SUBJECT: TRANSMITTAL OF THE BOFORS NOBEL SUPERFUND SITE SECOND
AMENDMENT TO THE RECORD OF DECISION FOR THE FIRST
OPERABLE UNIT

DECLARATION FOR THE SECOND AMENDMENT TO THE RECORD OF DECISION

Bofors-Nobel Site
Muskegon, Michigan

FIGURE 4 - PRELIMINARY LAYOUT OF INSTALLED VEGETATION

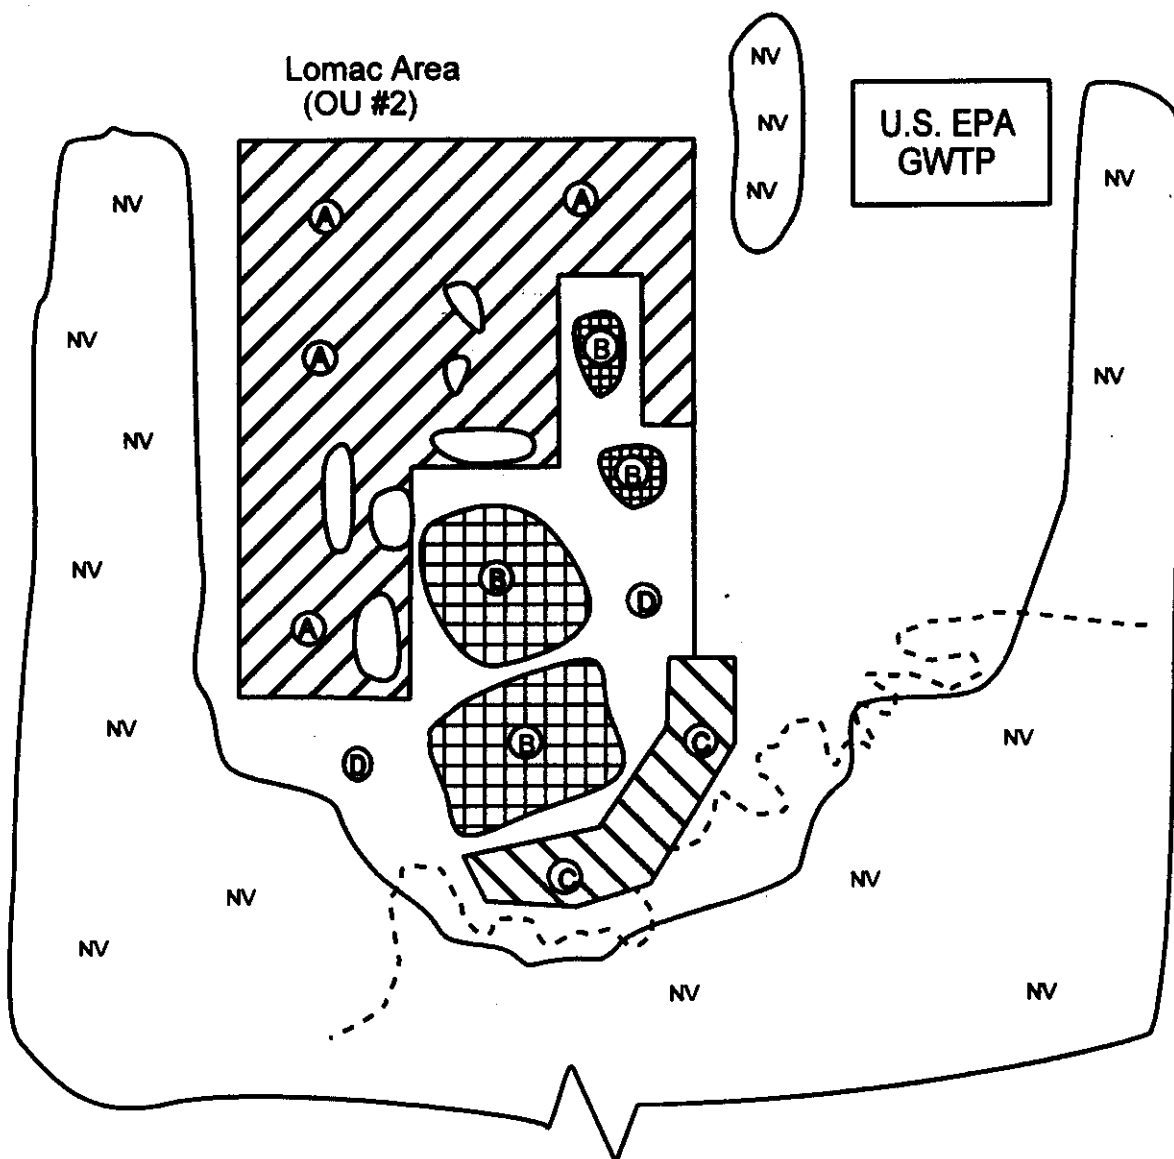
Are there different types of plants that are going to be used based on different types of contamination? Is there any plan to fertilize the trees?

To date, there are two species of trees that have been identified in the preliminary TIC remedy proposal, poplar and red cedar. These species have been selected because of their durability and fast-growing nature, and not because of any particular contaminant. Specific analysis regarding the treatment effectiveness of these (or other) species will be performed in more detail (including possible lab scale testing) during the Remedial Design process. Documents that have been included in the Administrative Record for the site suggest that the current lack of growth in the sludge lagoons is not due to toxicity from contamination, but from the lack of nutrients necessary for plant growth. Investigation of other construction in the local area (such as roadways and buildings) shows that once native plant species are disturbed, natural re-growth does not occur easily. U.S. EPA anticipates that installed vegetation will likely require introduction of water and fertilizers to insure adequate growth.

FIGURE 6 - PRELIMINARY LOCATION OF BARRIER WALL

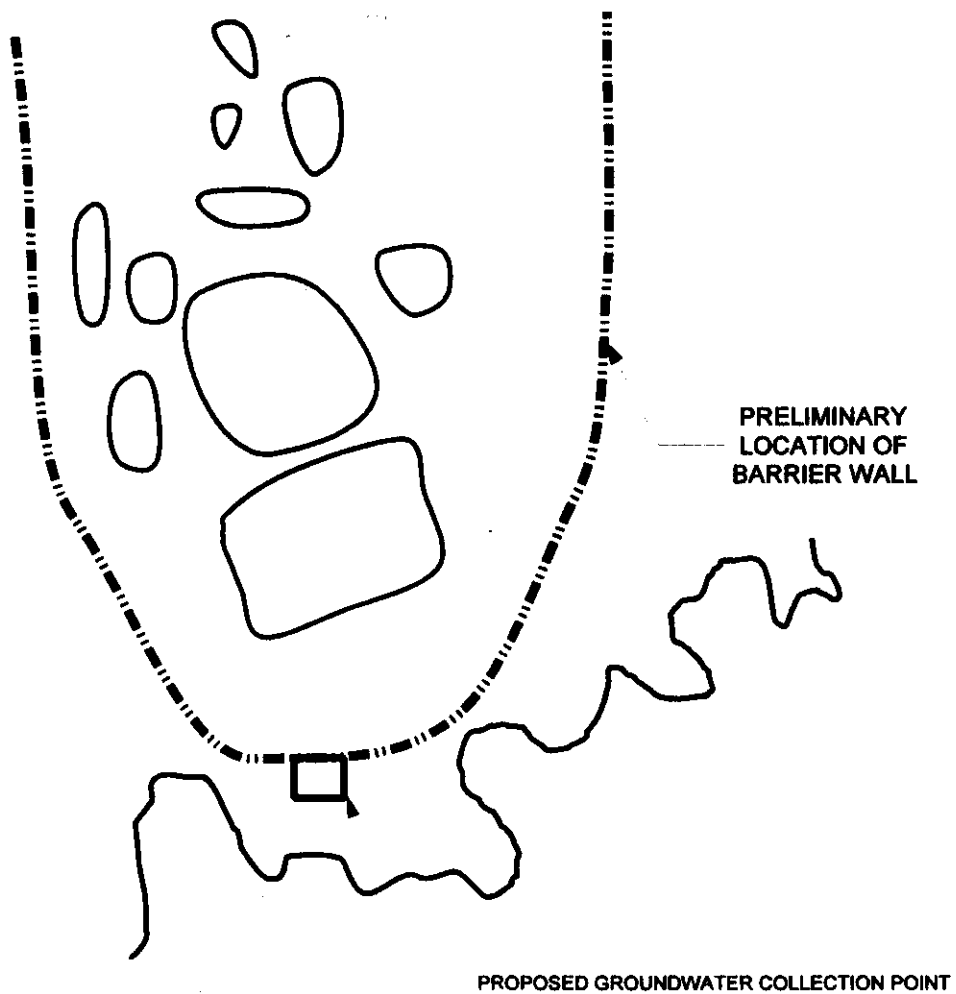
Although U.S. EPA anticipates using steel sheet piling for the barrier wall construction, how will it be possible to get clay down to the 75 to 100 foot depth without the excavation collapsing?

U.S. EPA anticipates that the use of sheet piling should stabilize any excavation wherever clay is used for the barrier wall component of the TIC remedy. In addition, the density of the clay slurry mix that is used can be increased to provide a more stable foundation within excavated areas and prevent any collapse. Slurry walls have been constructed to depths up to 100 feet at other sites throughout the United States.
